JEFFERSON MS NEW CONSTRUCTION
823 ACACIA STREET
OCEANSIDE, CA 92054
OCEANSIDE UNIFIED S.D.

Request for Information 032

SHEET TITLE
MECHANICAL
SCHEDULES
M-1.1

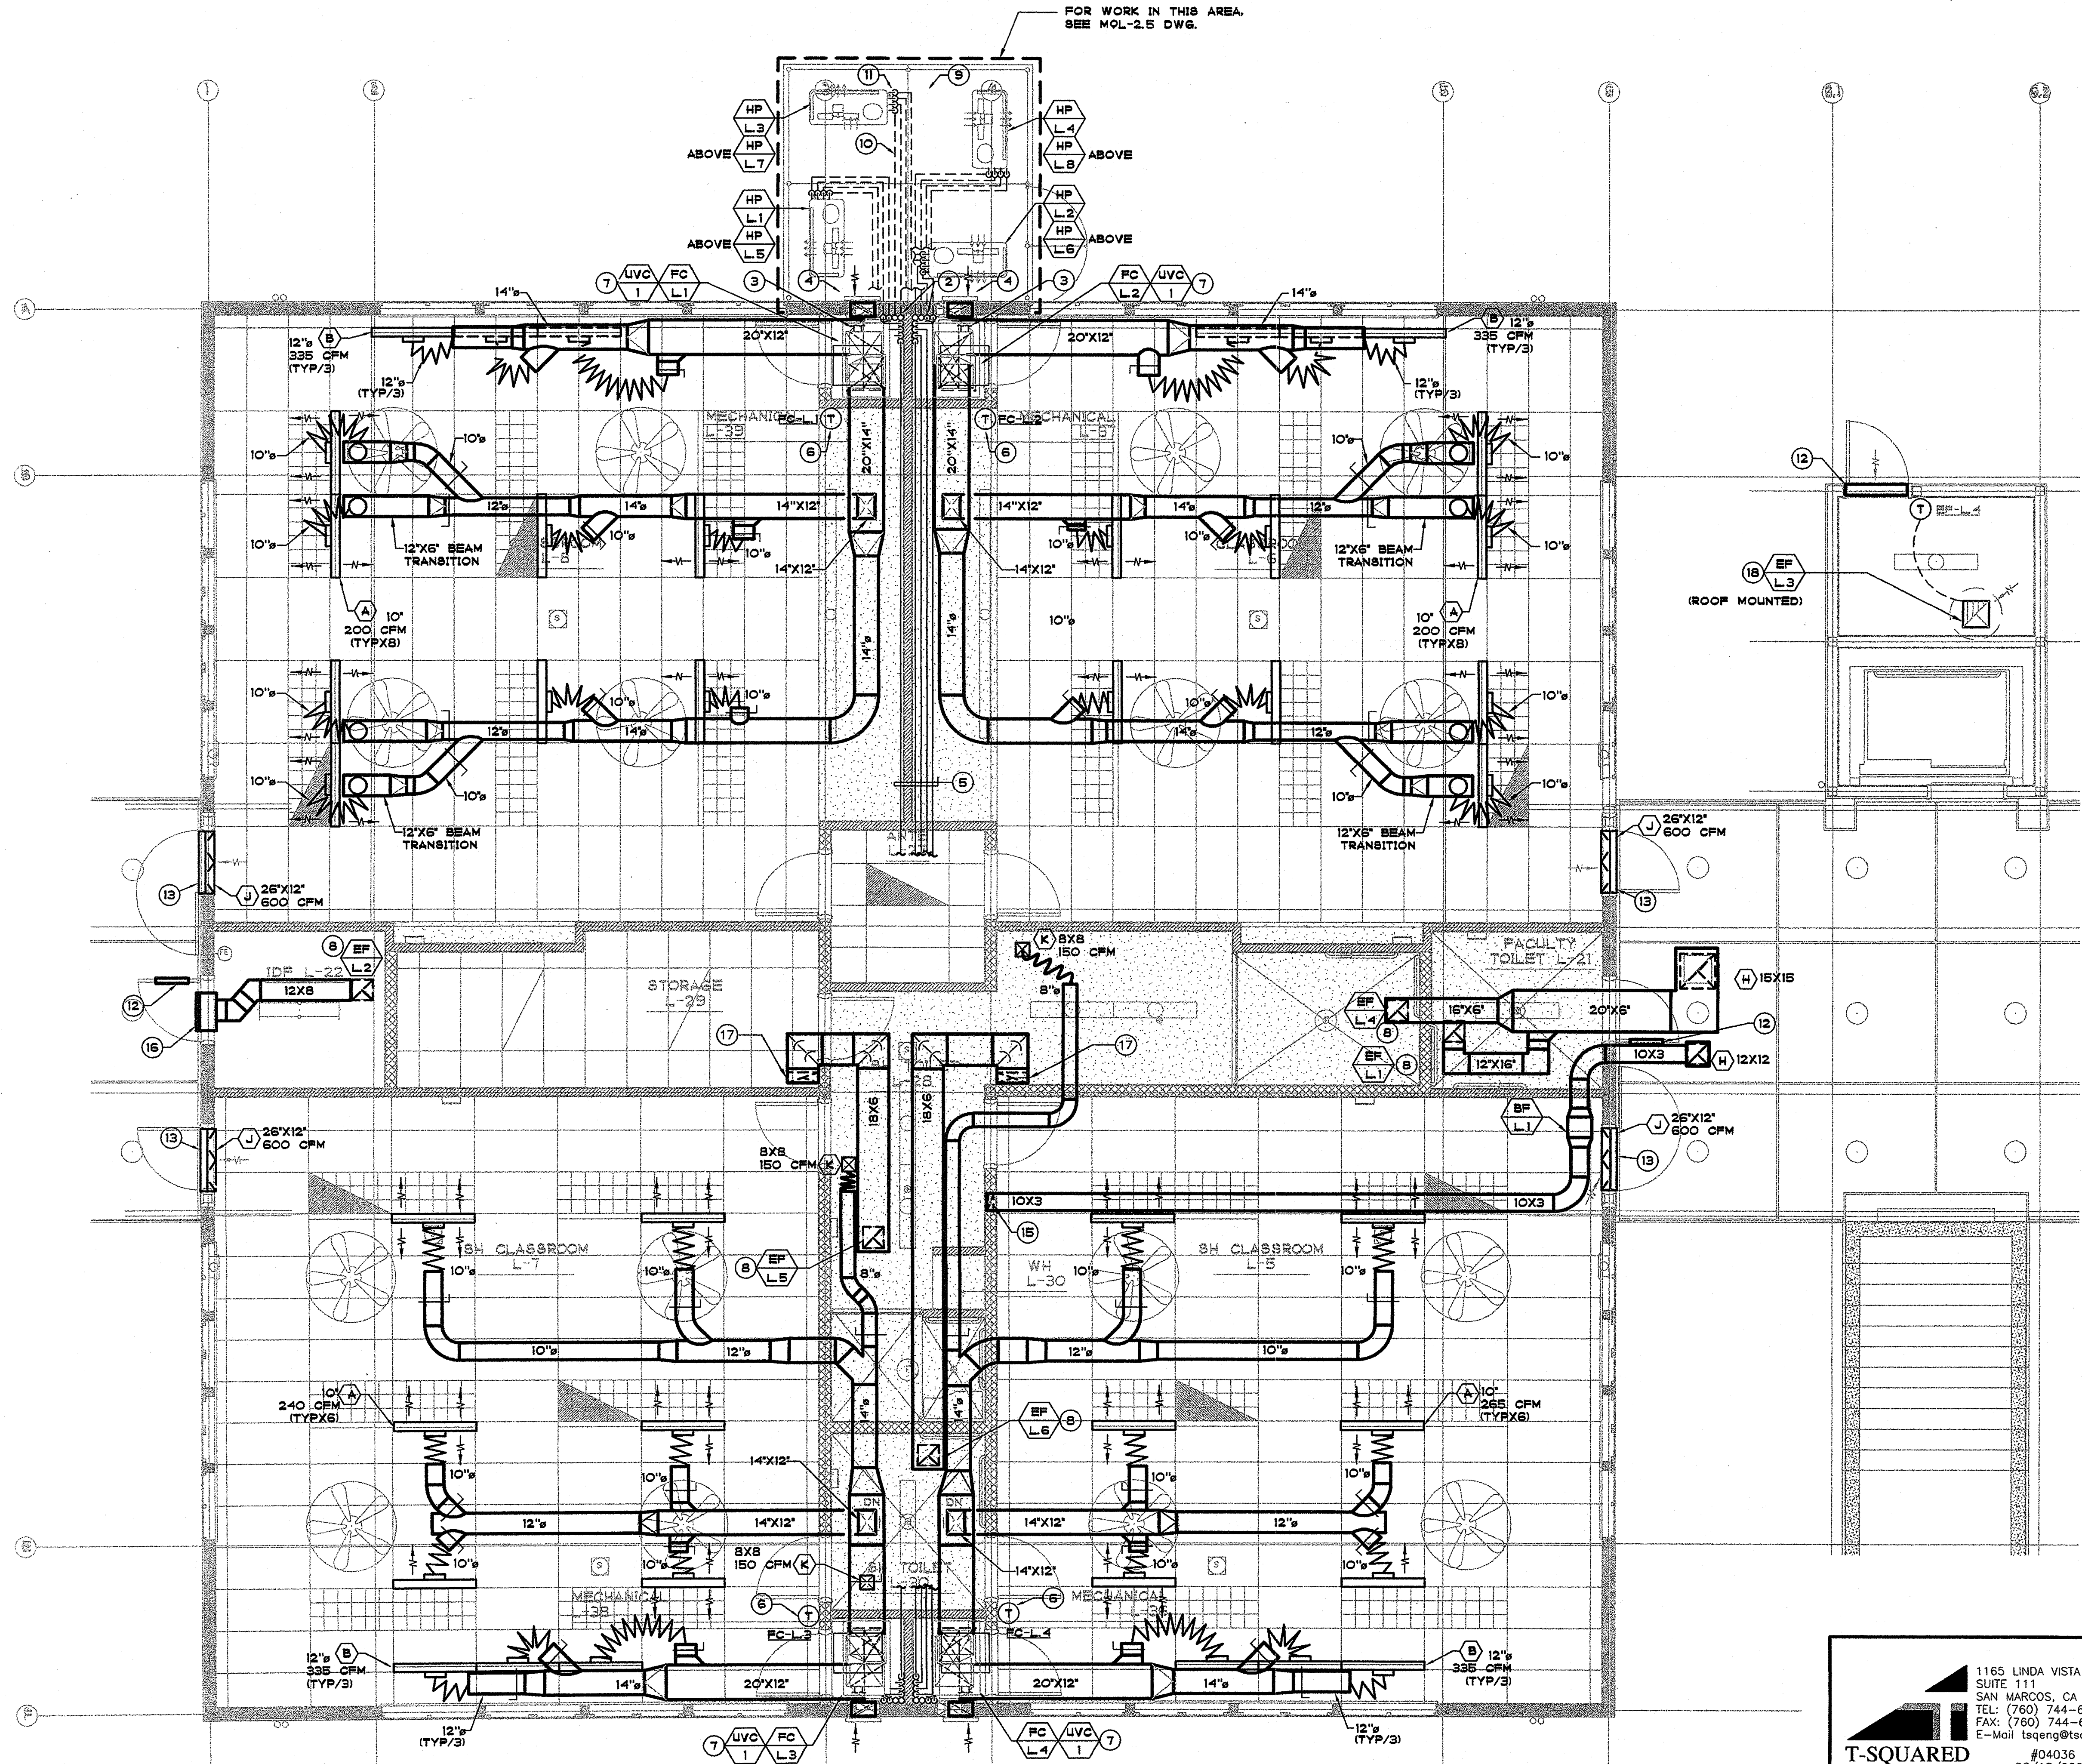
Question
Per General notes on sheet M-1.1 Item # 14 is call out for fire smoke dampers penetrating fire rated walls. Mechanical plans MCL 2.1, 2.2, 2.3 & 2.4 Shows duct work penetrating from Mechanical room into classrooms, as well as the outside air louvers with no fire smoke dampers. Are fire smoke dampers needed?

Answer
Per note #14, sheet M1.1, and also per cbc 2001 the version under which this approval was granted, fire/smoke dampers shall be installed on all ductwork passing thru fire separating walls. I think this specifically covers the entire project. Electrical dwgs do not show the ckt's for wiring these, and therefore do the following to wire these devices:

SHEET TITLE
 BUILDING L
 FIRST FLOOR
 POWER PLAN

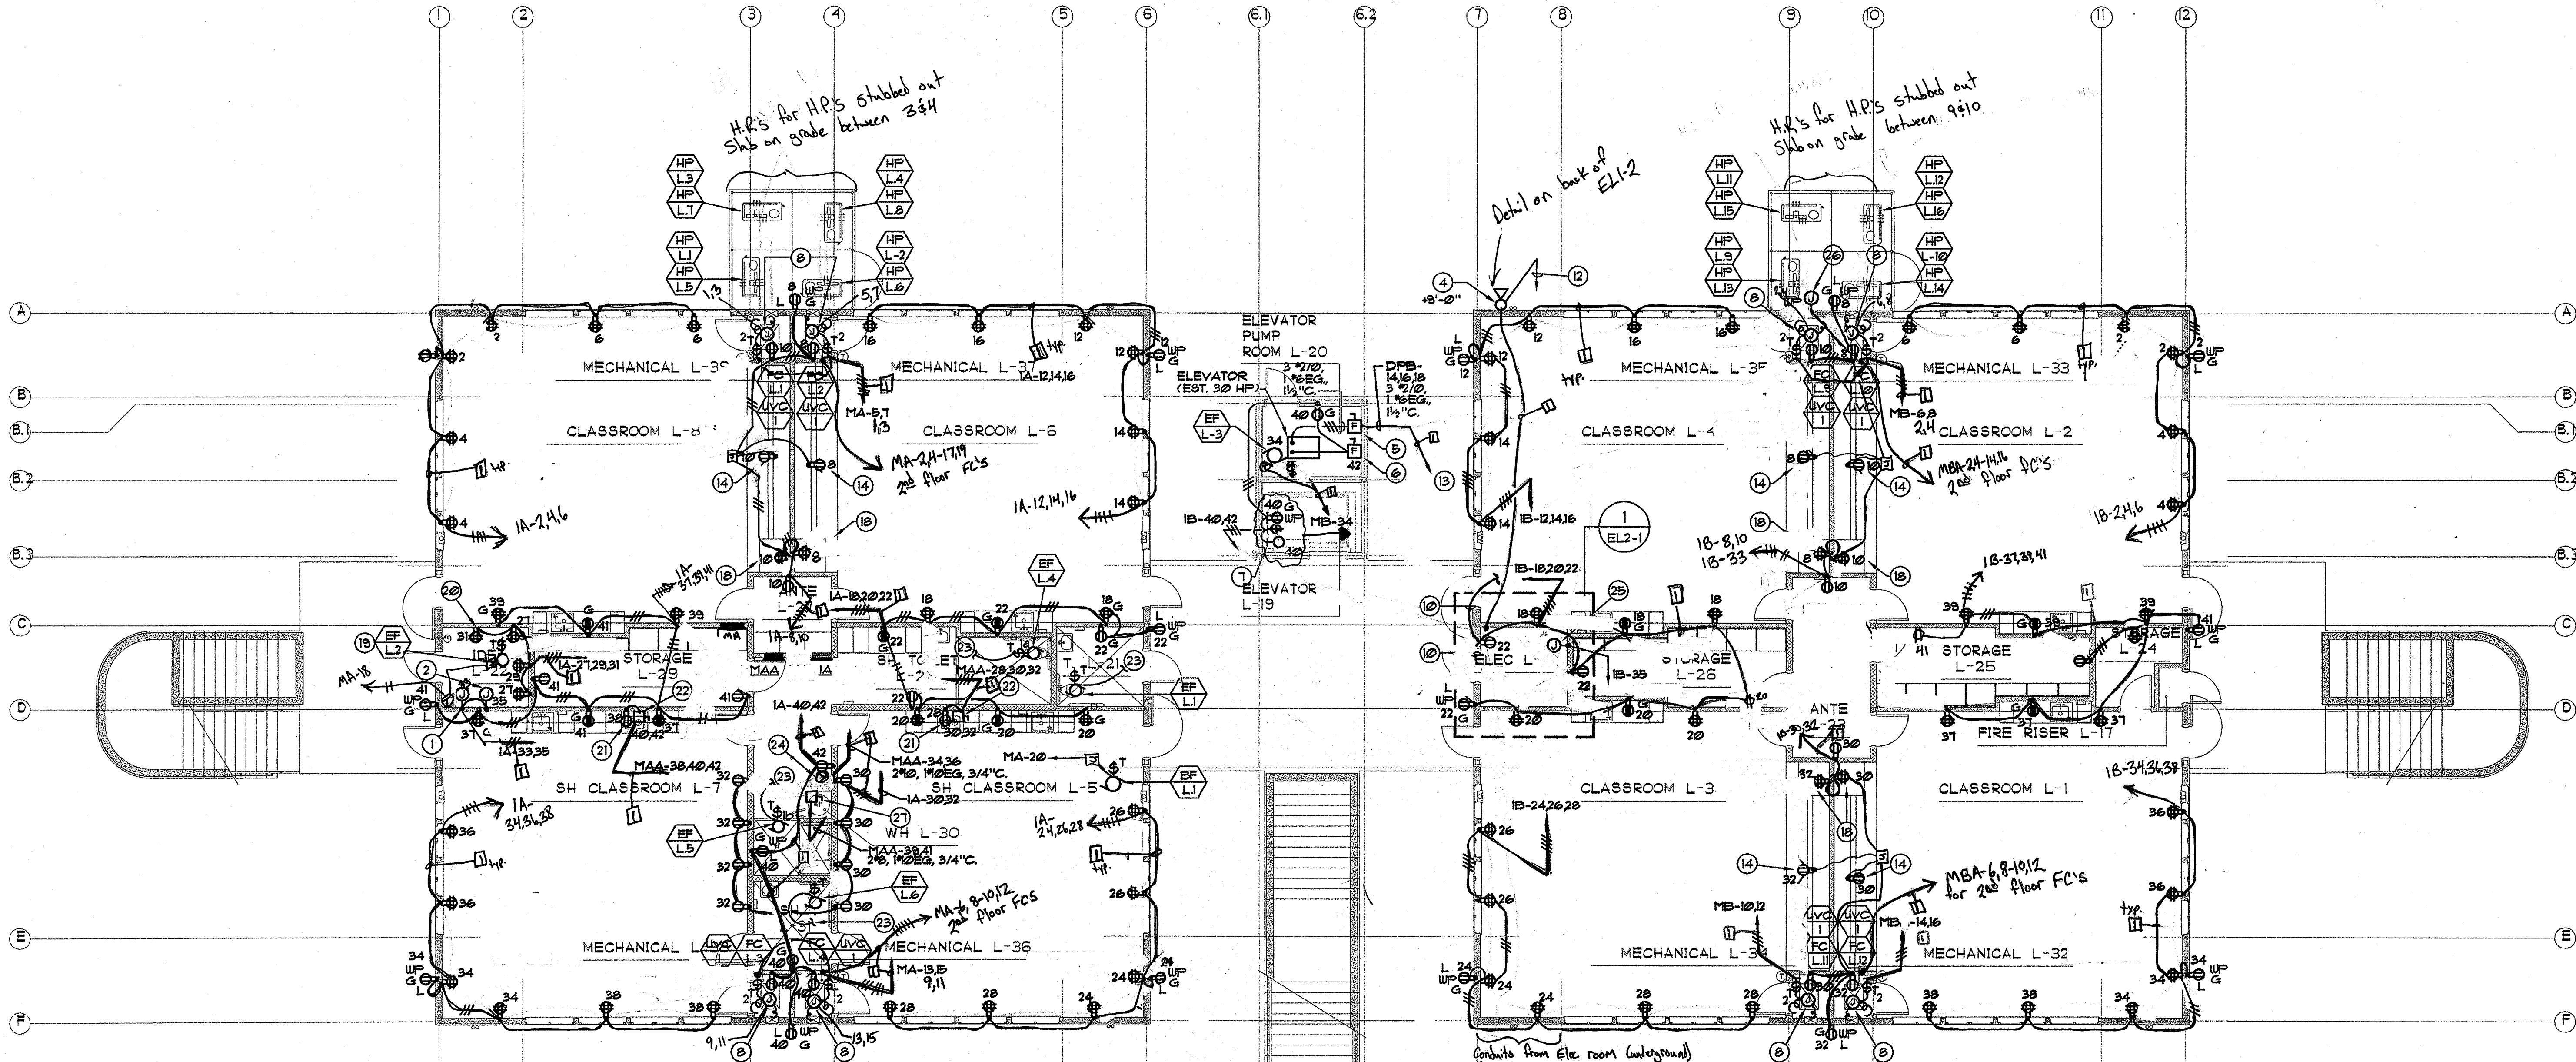
Question Date Required: 7/15/2005
Reference sheets EL2-1 and AOL3-1. In building L at grid lines 3 & 4 and C on the 1st floor there is a wall shown with (3) flush panels that has Pn's MA, MAA and 1A in it. 1st of all this wall is only 4" deep and panels 1A and MAA are 5.75" deep. This wall needs to be a 6" wall.
Next Pn's MA because of the amount and size of breakers in this panel can only come surface mount and is 75" h x 32" w x 10" d. Also because the door swings out (3) panels can not fit here anyway.
Gould electric has attached a drawing showing our proposed location for panel MA now. Please advise if this location is acceptable and if the wall housing for 1A and MAA will be changed to a 6" wall.
Also please look at the second floor recessed panel locations. Panel 2B and 2A need to be at least 6" walls, which it appears they are, but the same wall where 2B is shown there is also elevator signage shown. Attachment will be faxed.
